PLAN AND PROFILE OF PROPOSED STATE HIGHWAY

PRINCE WILLIAM PARKWAY INTERCHANGE AT REALIGNED BALLS FORD ROAD

VDOT Proj.No.6234-076-266

Notice of Design Change (NDC) #02
JUNE 2021

20(1)-2 to 20(3)-1

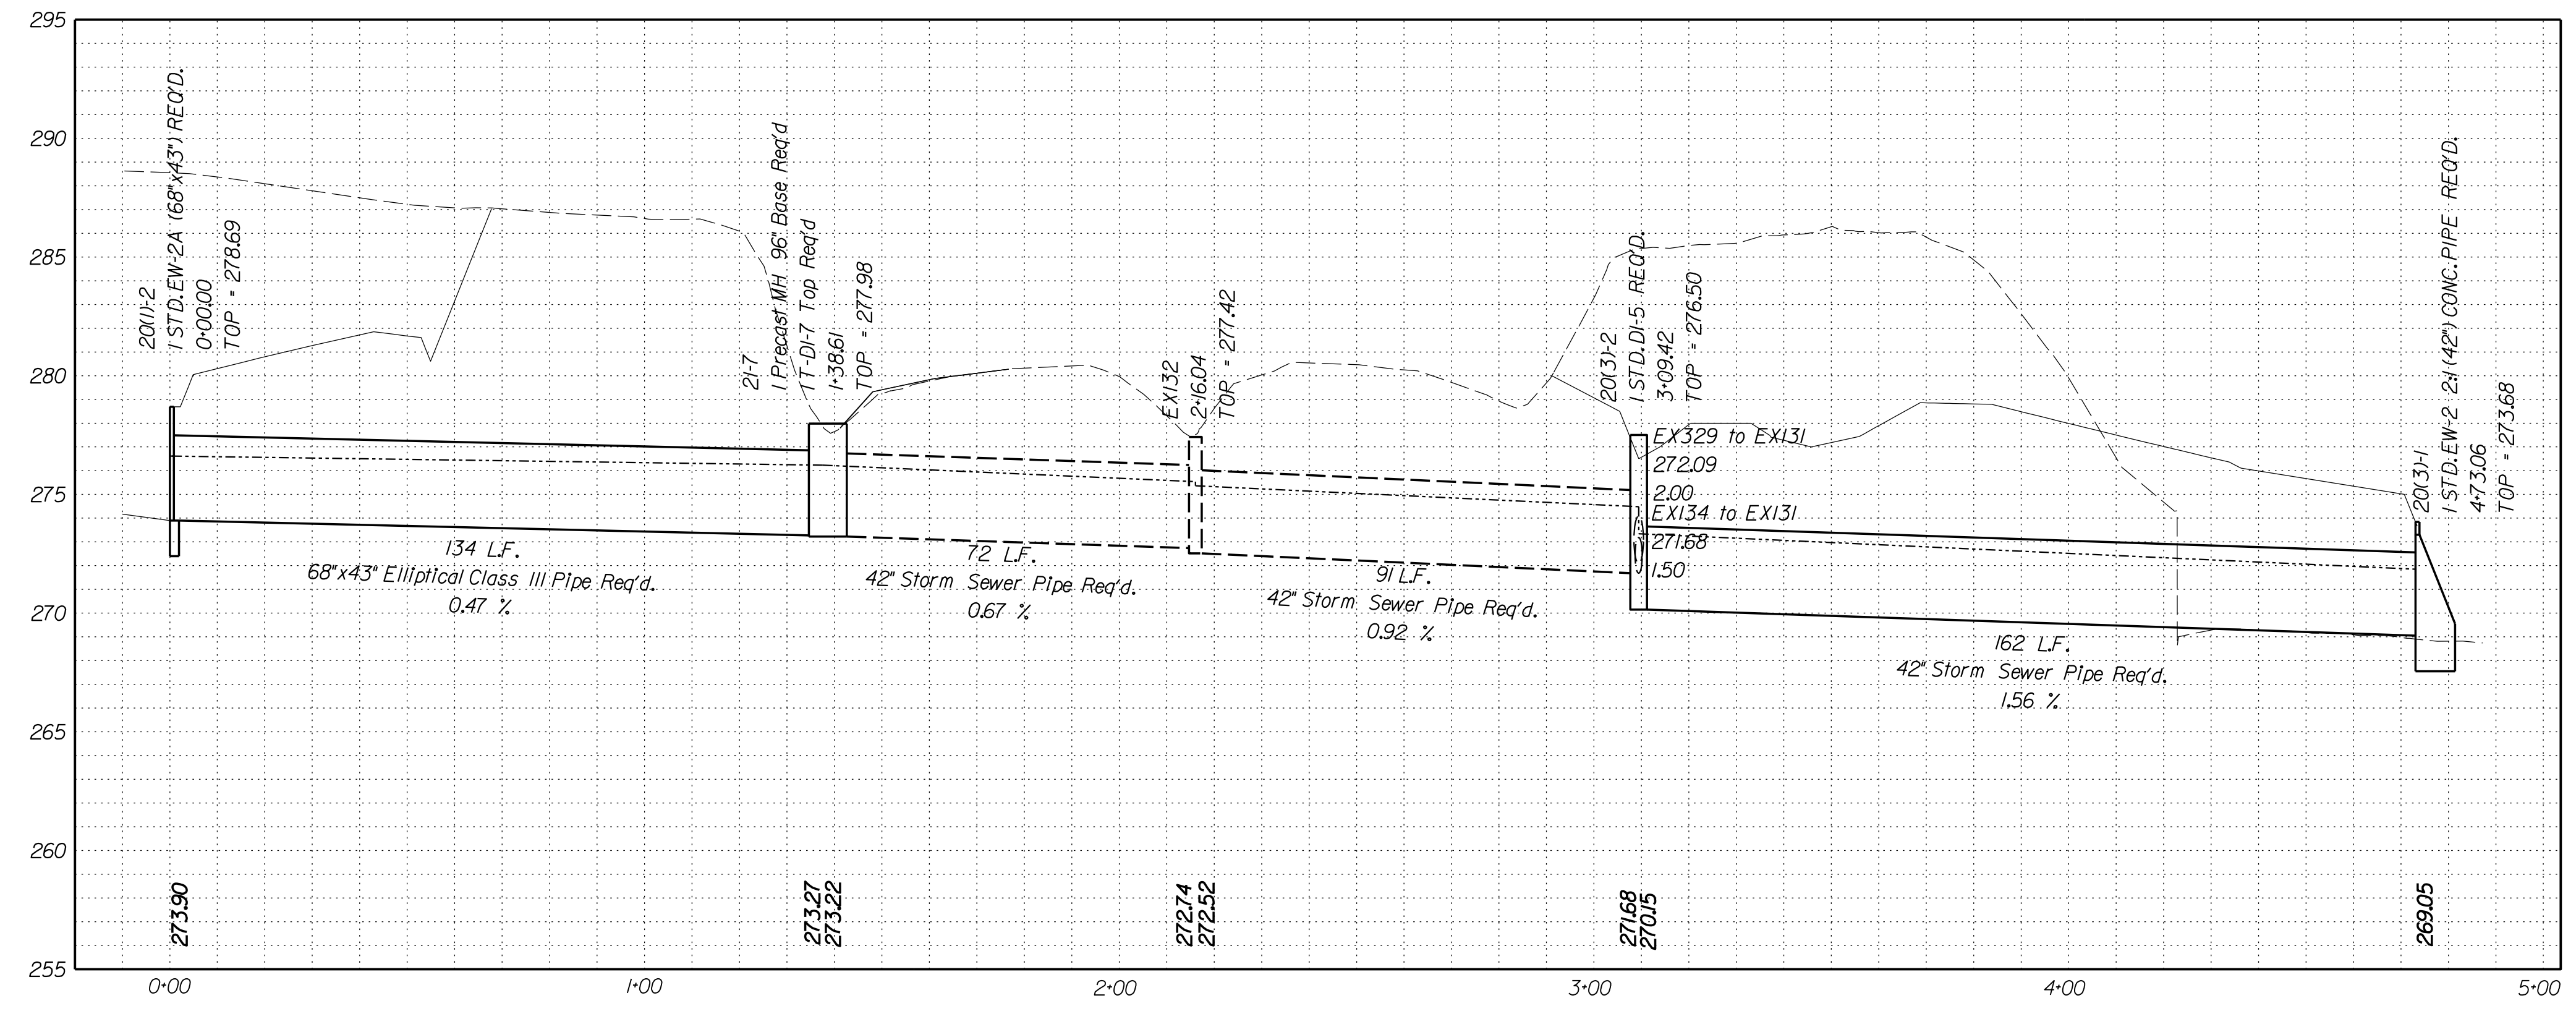
02 Revised 21-6 to 20(3)-1.

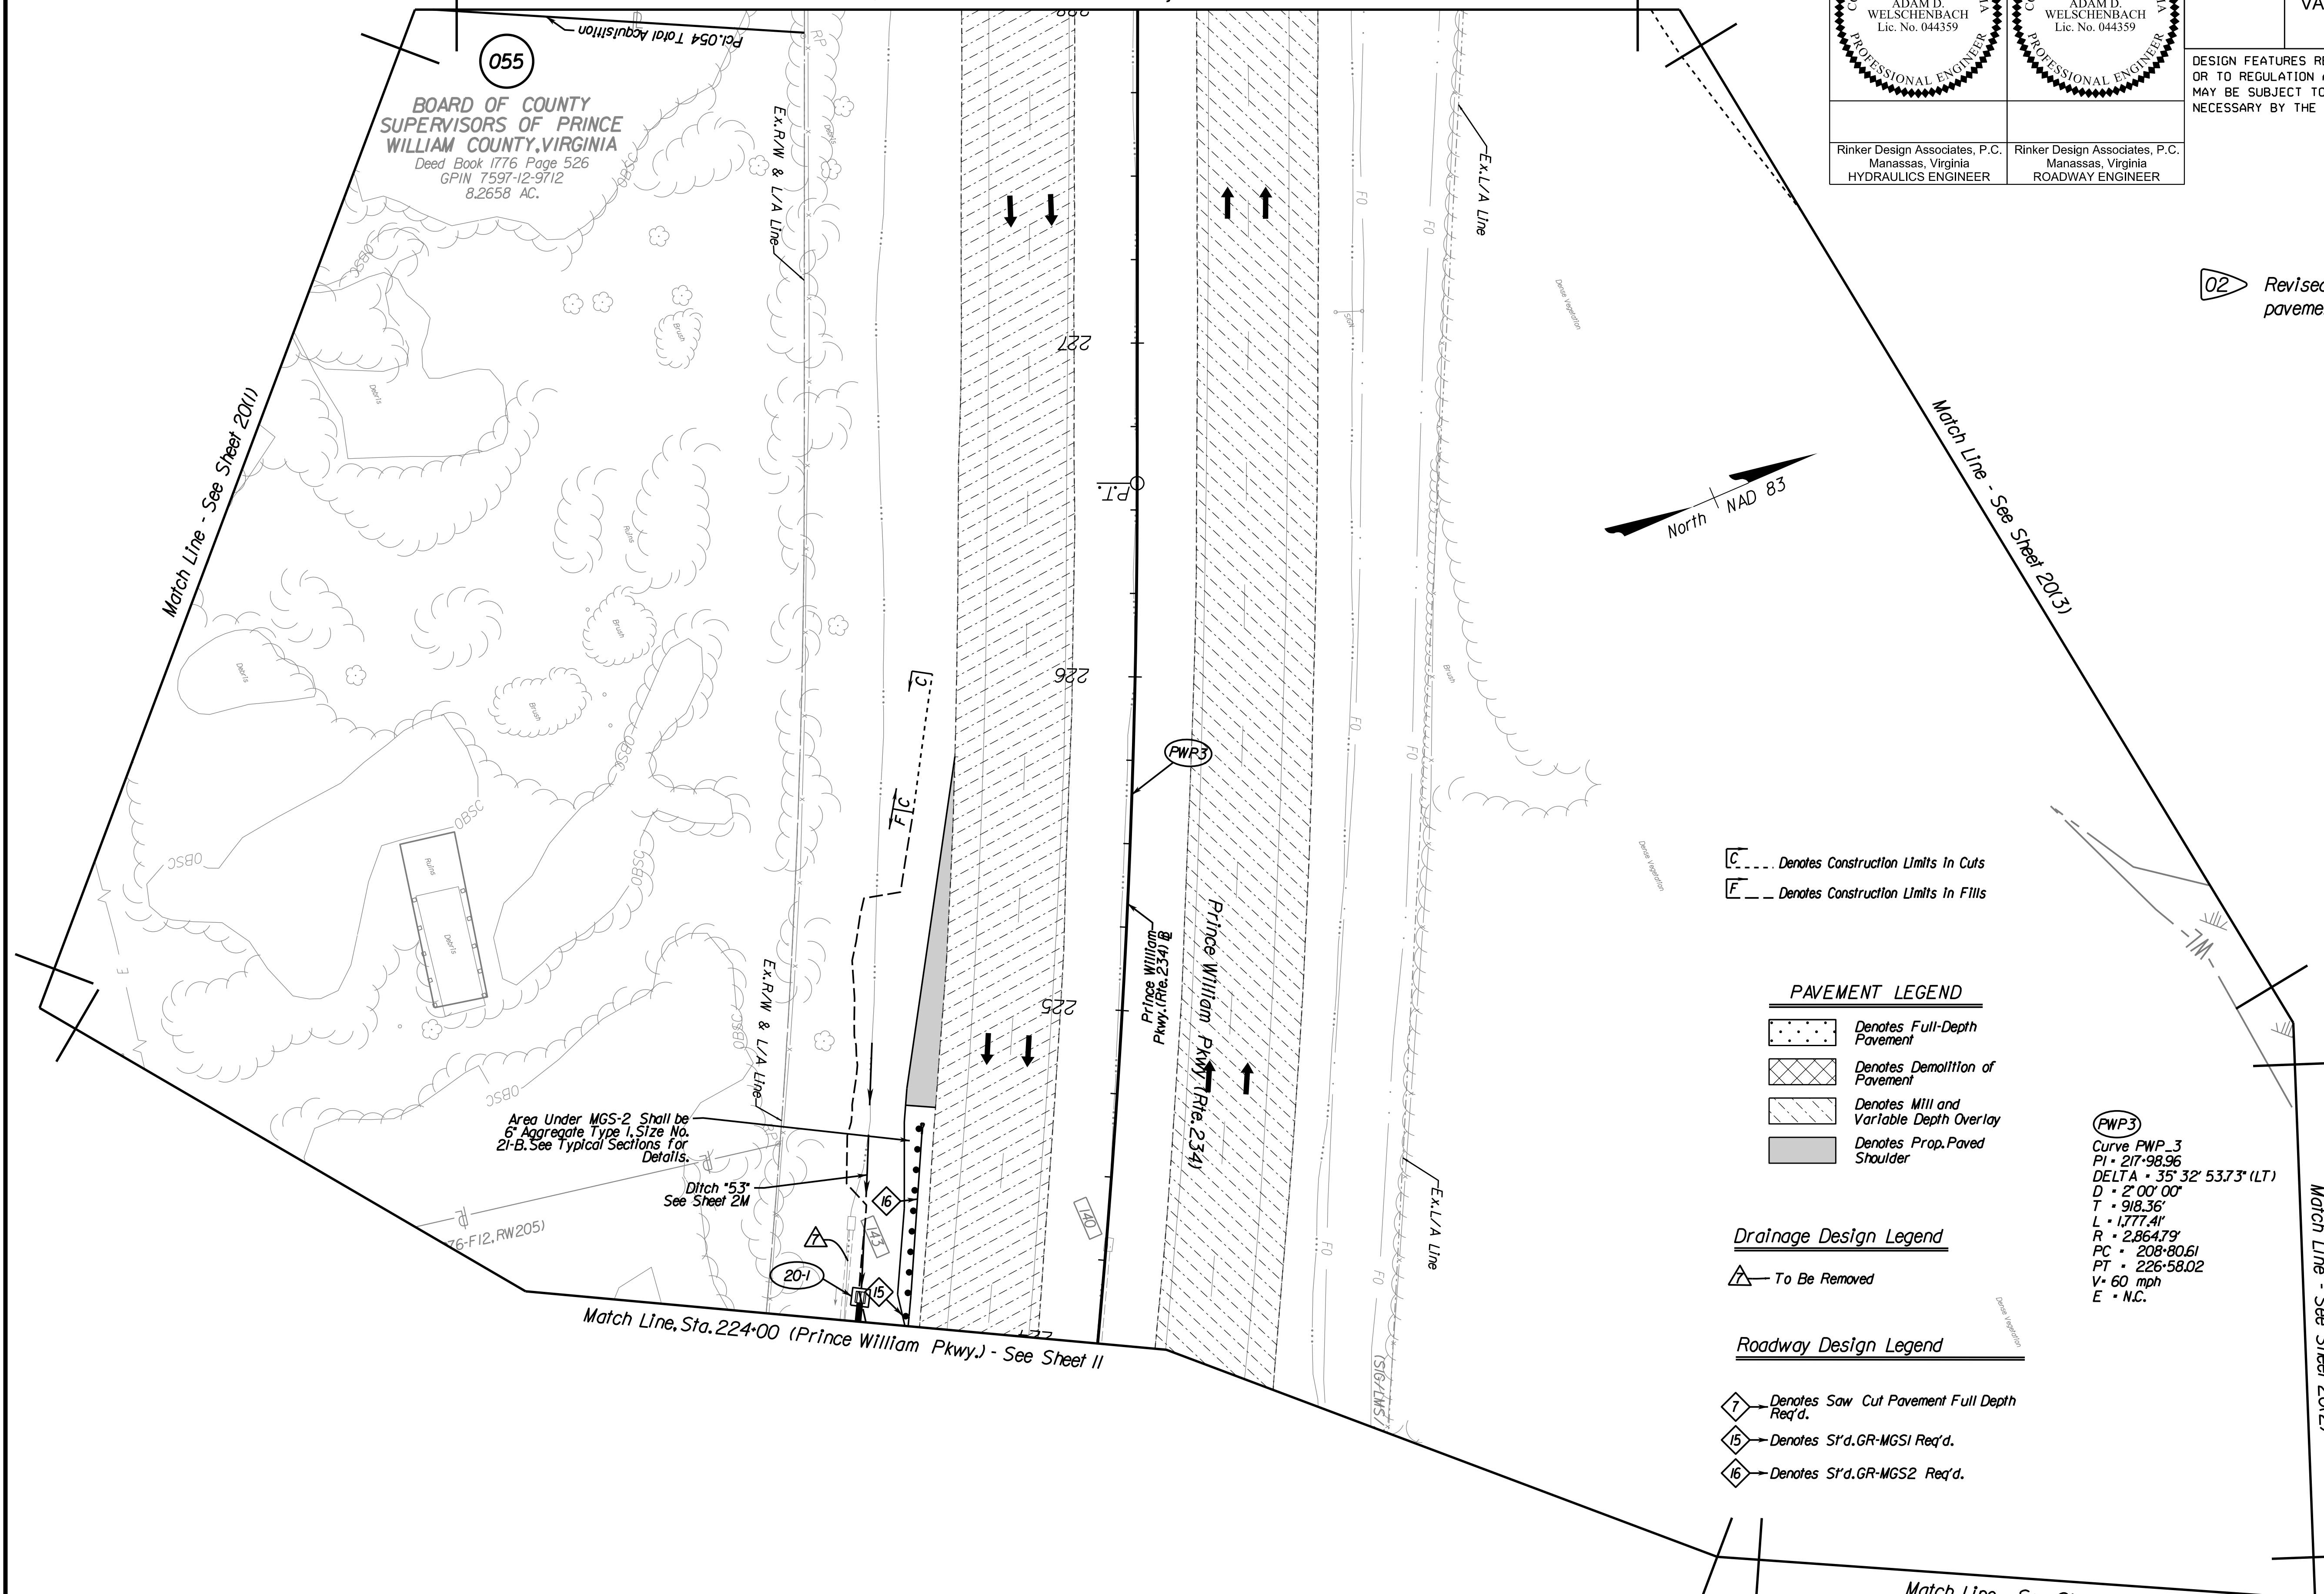
02 Revised shoulder section in pavement in front of BPPS.

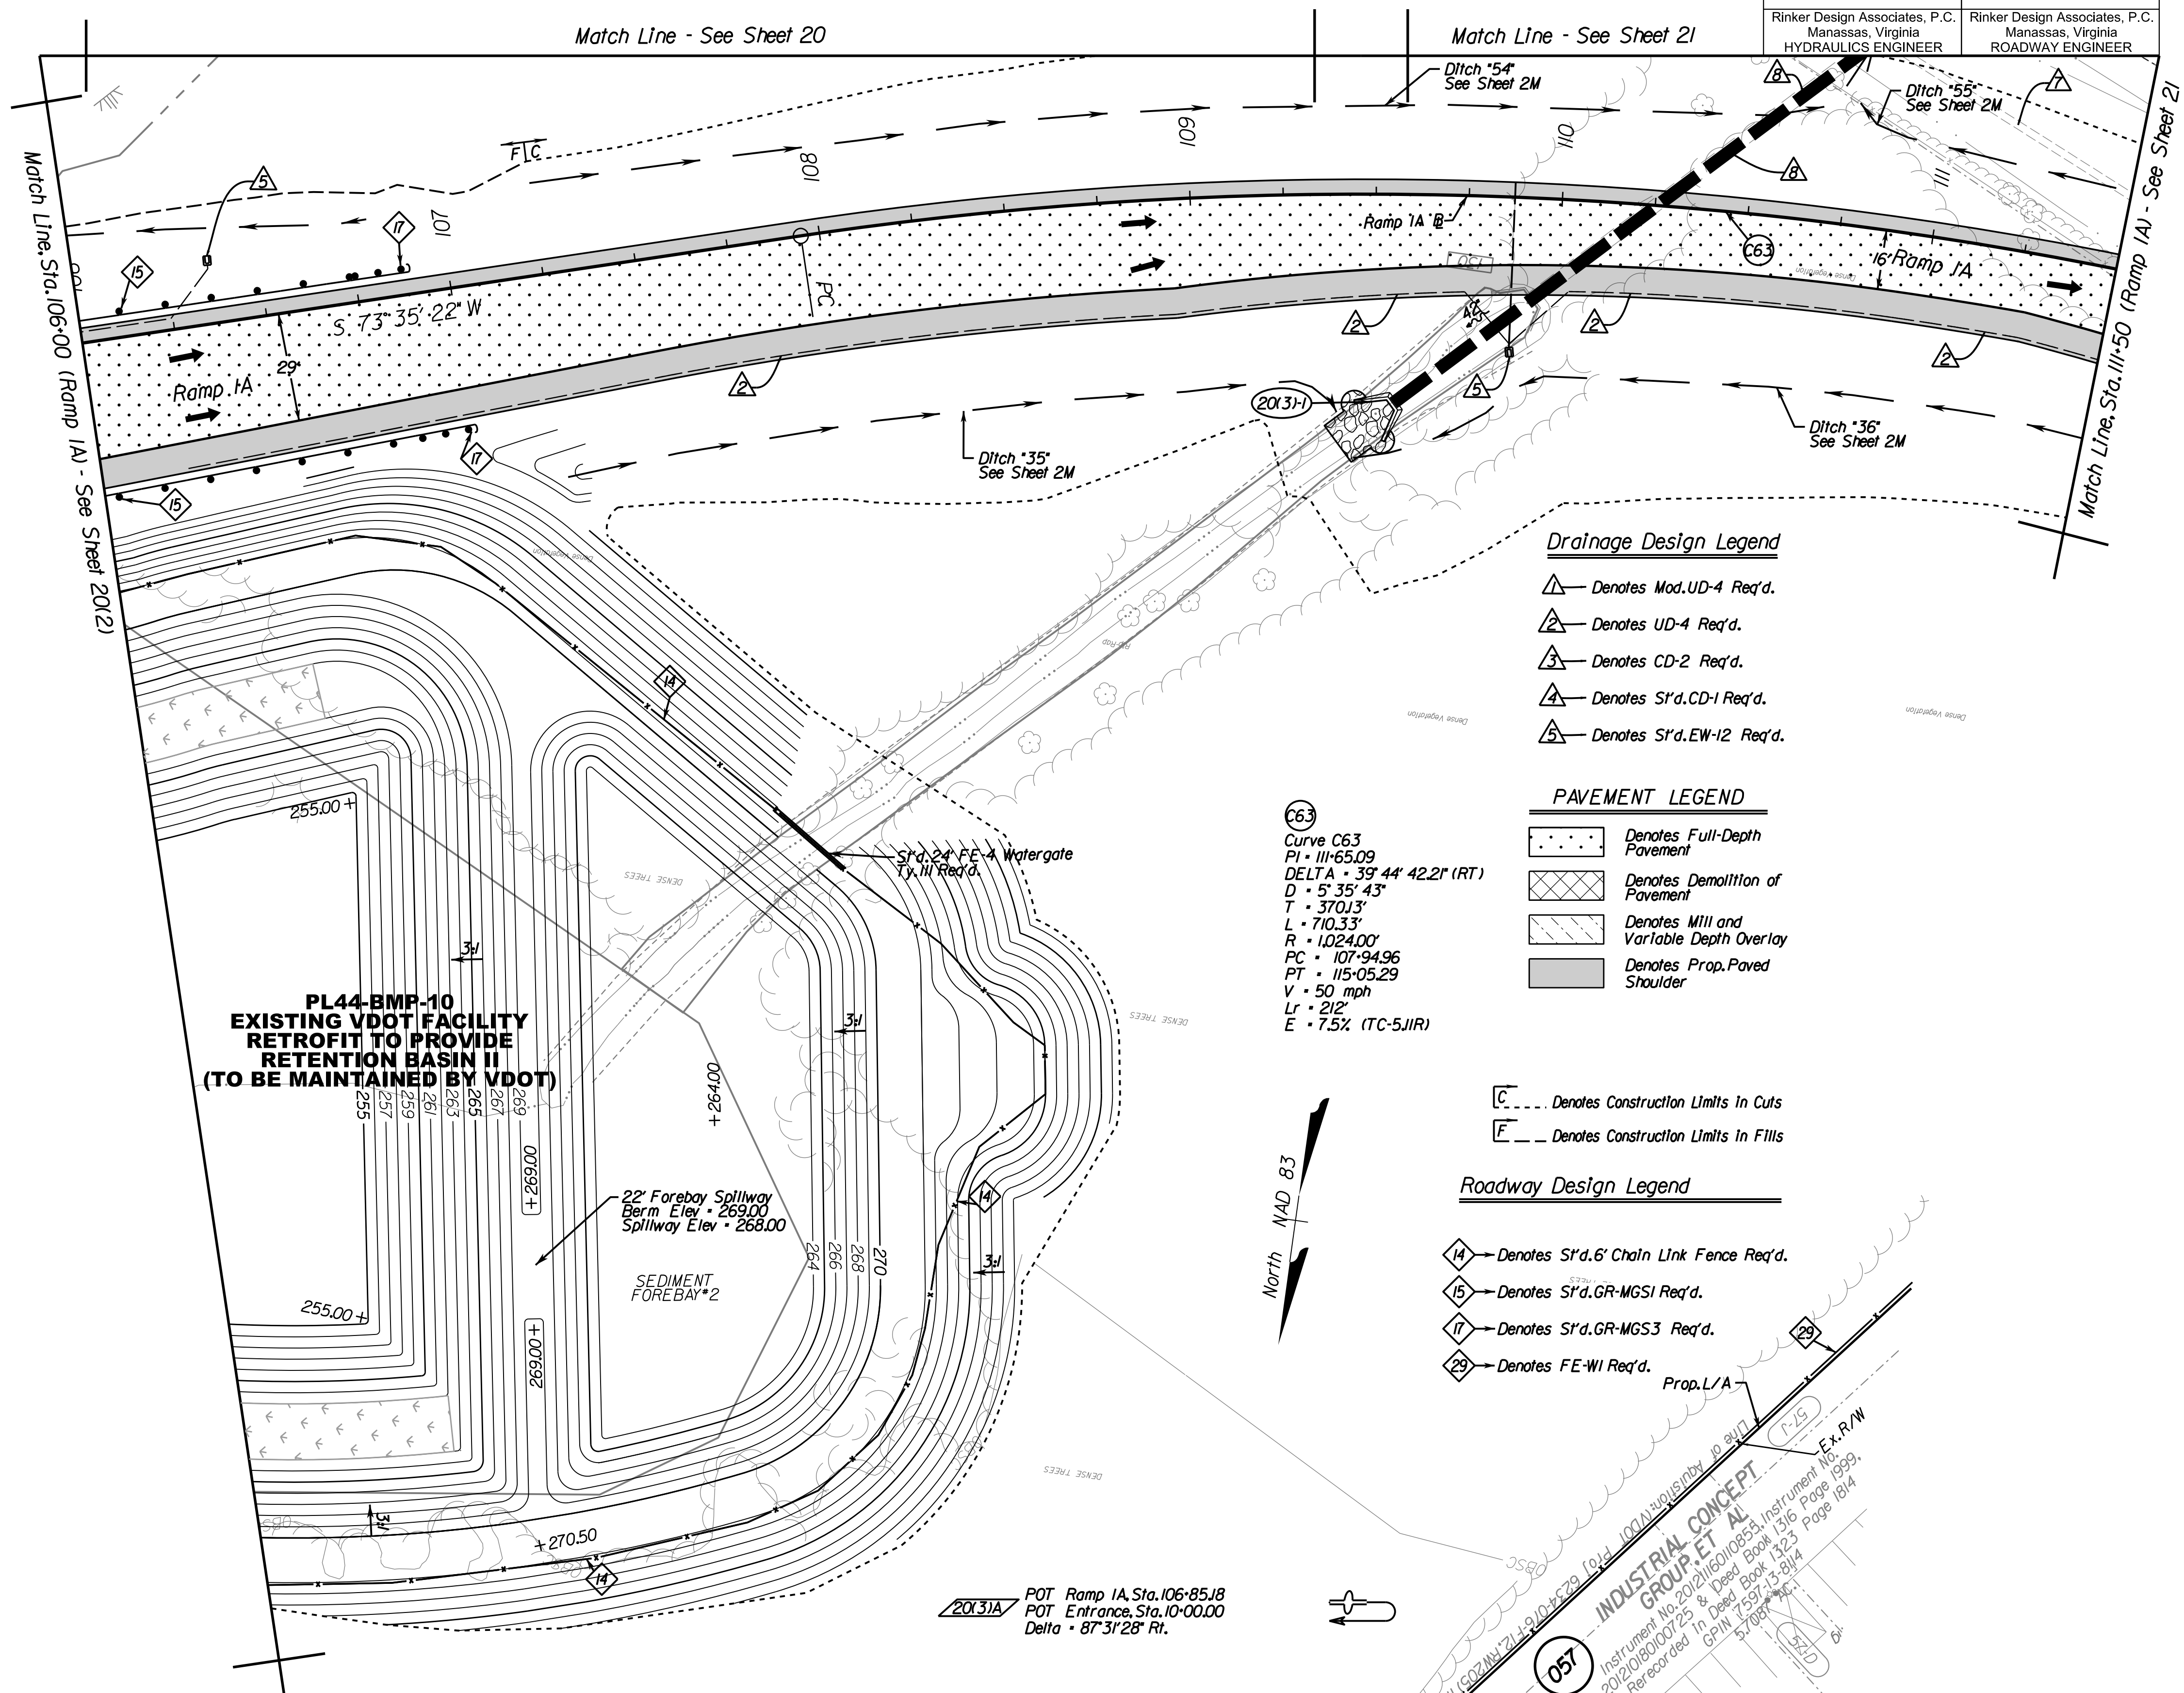
02 Added storm pipe 20(3)-1 to 20(3)-2. Removed 20(3)-3.
Realigned ditches around 20(3)-2.
